*Re: Addendum to Final Regional Water Supply Facilities Plan Report - Hidalgo County, Texas  
TWDB Contact No. 0804830848*

**ADDENDUM TO  
REGIONAL WATER SUPPLY FACILITIES PLAN  
FINAL REPORT (DATED APRIL 2011)**

To: Connie Townsend, P.E.  
From: Deren Li, PhD, P.E., D.WRE, CFM  
Date: May 20, 2011  
Re: Responses to TWDB Review Comments on Final Report of Regional Water Supply Facilities Plan (April 29, 2011)  
TWDB Contract No. 0804830848

Figure 1-1. Hidalgo County and Hidalgo County Drainage District No.1

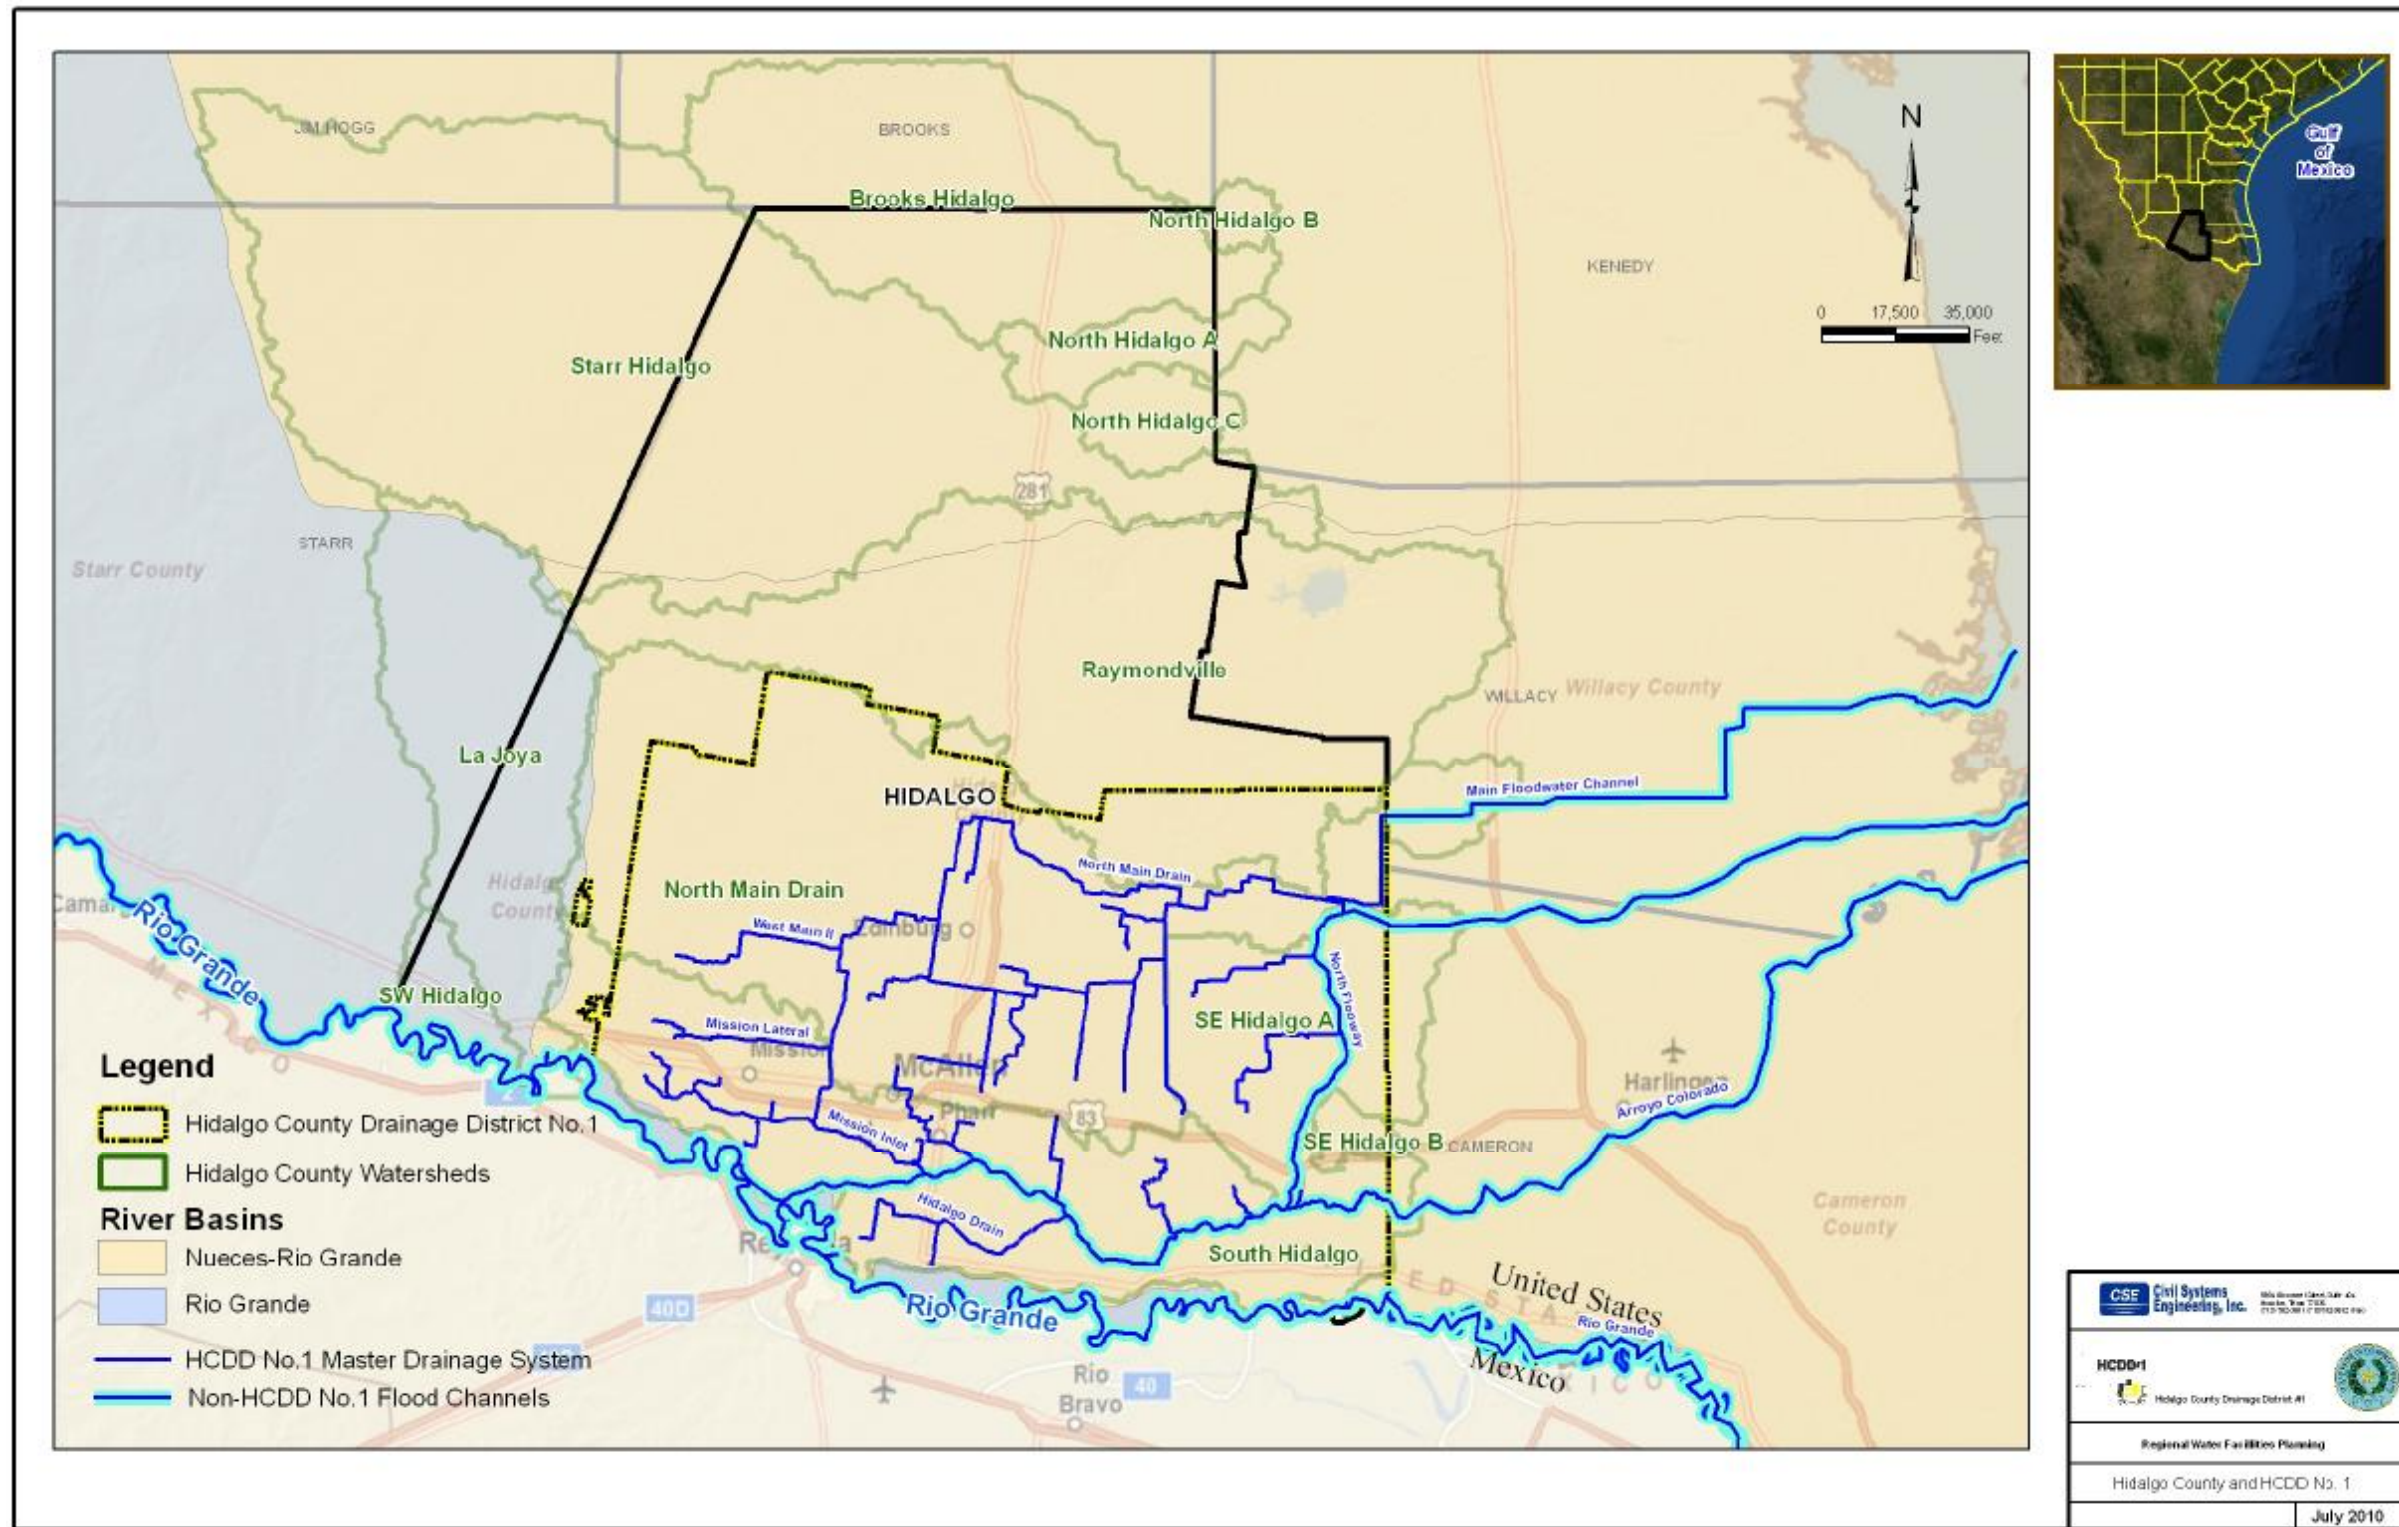
5. *Page 1-4, Figure 1-1: It appears that delineation is missing between district-owned drainage canals and the floodway canals owned by the IBWC and others. In the final report, please identify these other drainage networks separately and add to the figure legend.*

Response: The report Figure 1-1 has been updated accordingly to distinguish between HCDD No. 1 and non-HCDD No.1 streams.

Figure 3-4. Current Water Supply Network and Service Areas

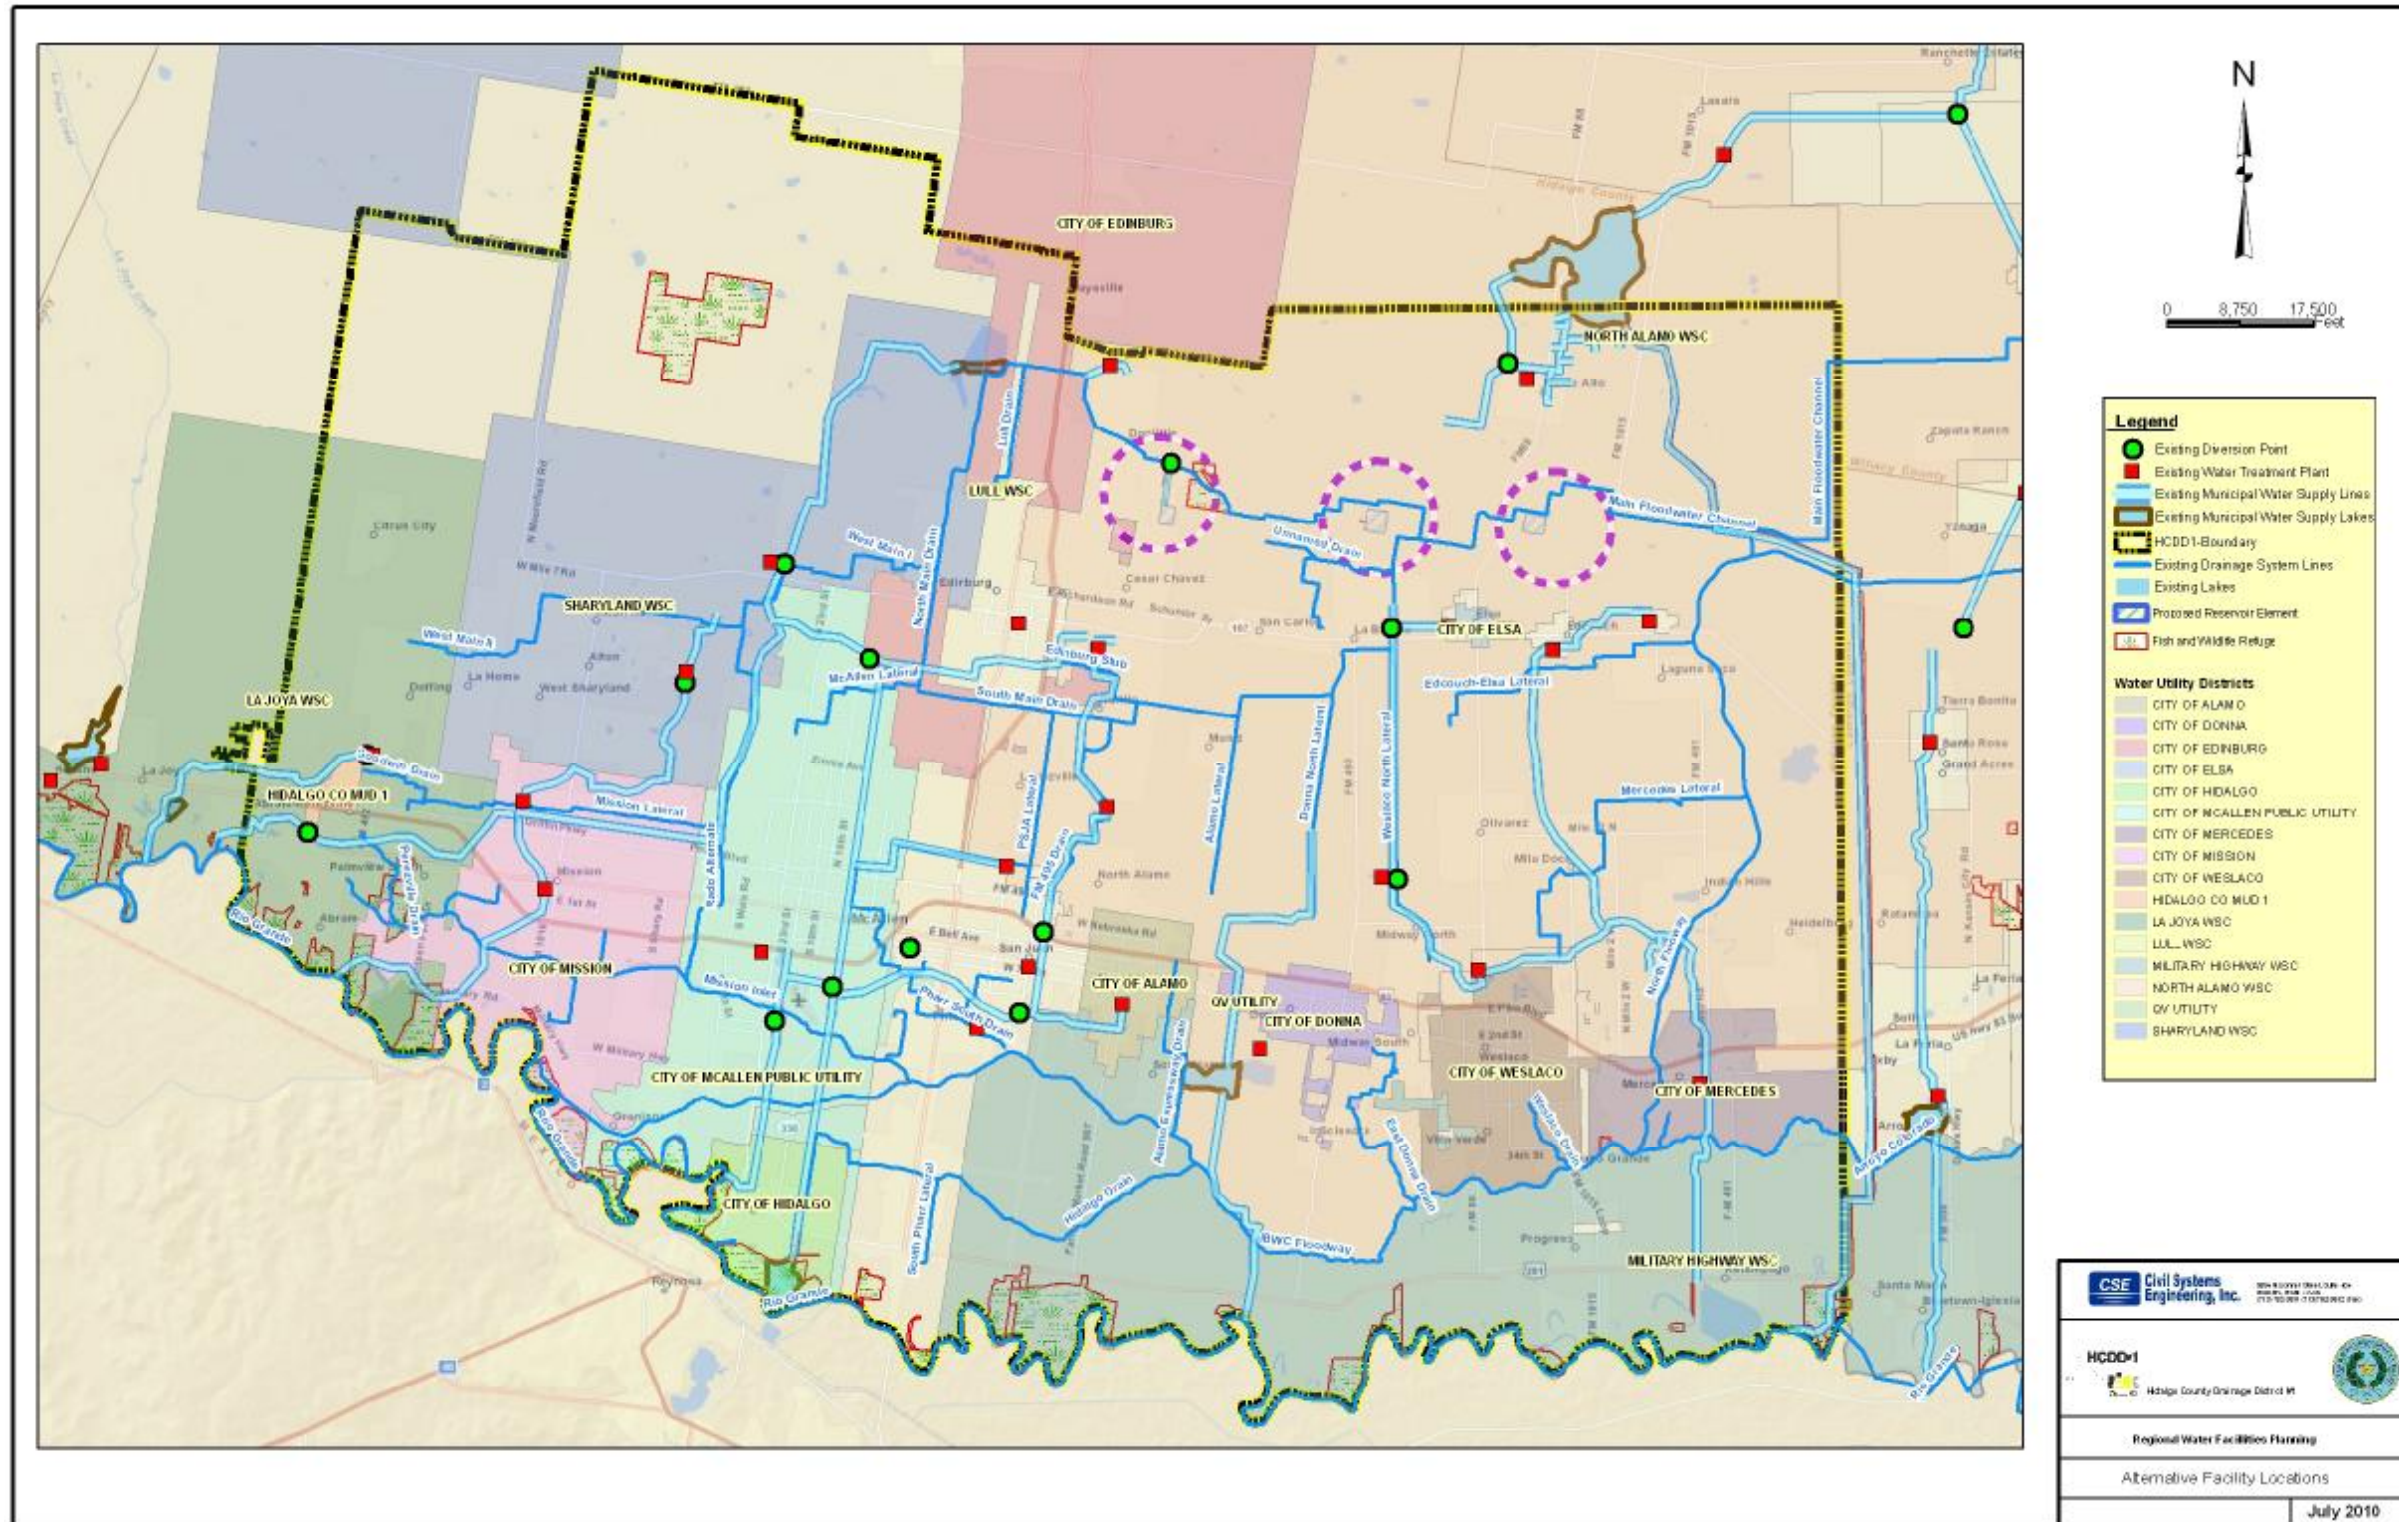
10. *Page 3-8, Figure 3-4: The CCN service area boundaries for each water utility appear to be missing in Figure 3-4 and its legend (as referenced in text on page 3-4, column 2 of the draft report). Please include in final report.*

Response: Figure 3-4 of the report has been updated to reflect the missing CCN service areas.
